# UNITED STATES PATENT AND TRADEMARK OFFICE

10/551,056

<b>Office Action Summary</b>	<b>Application No.</b> 10/551,056	<b>Applicant(s)</b> SHEZIFI ET AL.	
	<b>Examiner</b> LYNNSY SCHNEIDER	<b>Art Unit</b> 3733

## DETAILED ACTION

Figure 29

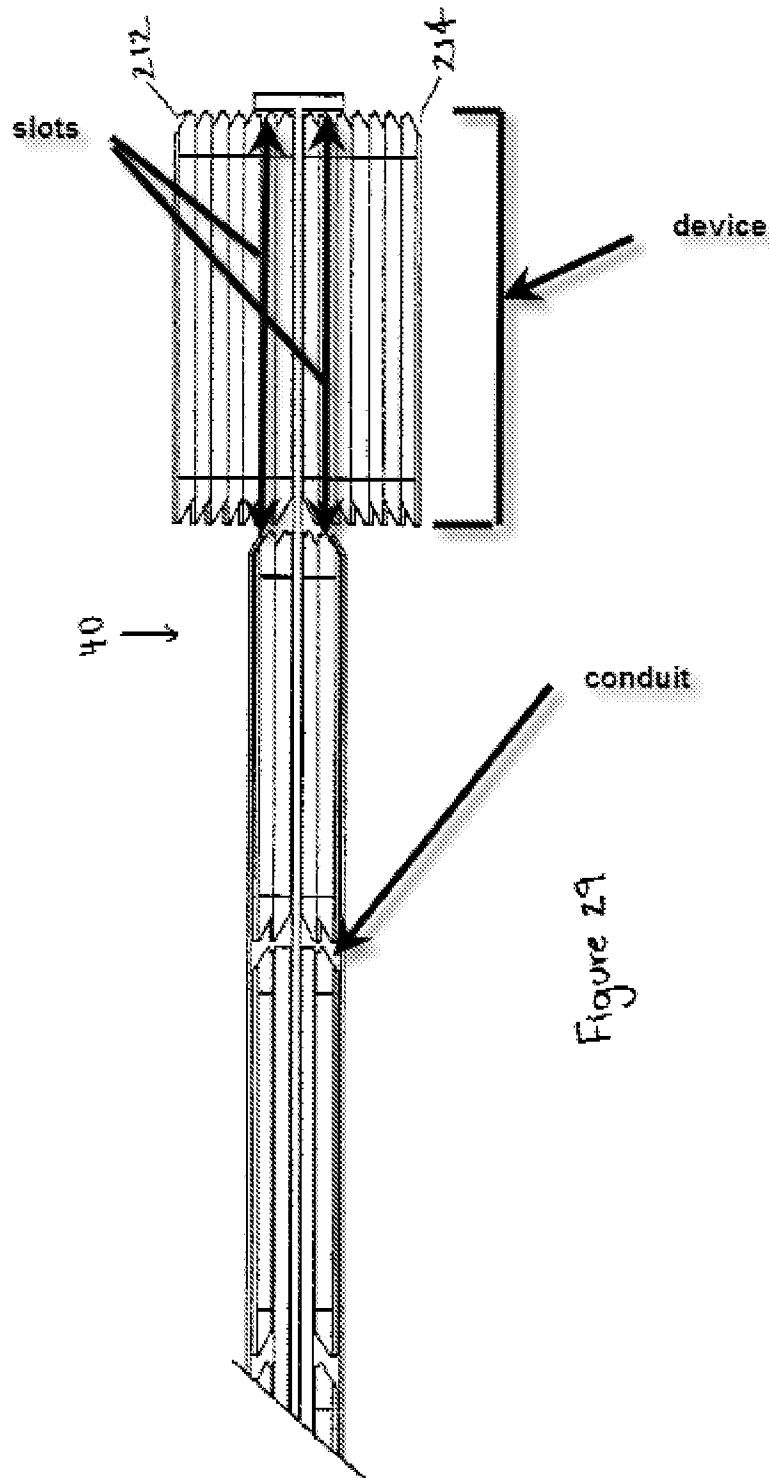
5. Claims 1 and 3 are rejected under 35 U.S.C. 102(e) as being anticipated by Johnson et al. (Pub. No. US 2002/0183761 A1).

Regarding claims 1 and 3, Johnson et al. discloses a device (figure 29) for distracting and supporting two substantially opposing tissue surfaces in a patient's body, to be introduced within the tissue surfaces in a minimally invasive procedure, the device comprising: a wrapping element (paragraph 0177 "permeable membrane"); and an expandable structure "wafers" insertable between the two substantially opposing support surfaces of the wrapping element, adapted to be expanded between the two substantially opposing surfaces to a predetermined dimension (figure 29). The device is further provided with an introduction member 50 (figure 29), the introduction member 40 comprising a substantially linear conduit (figure 29), having a proximal end through which the device is inserted and a distal end where two substantially opposite slots are

provided (figure 29), through which the expandable structure may protrude in directions substantially perpendicular to the conduit (figure 29).
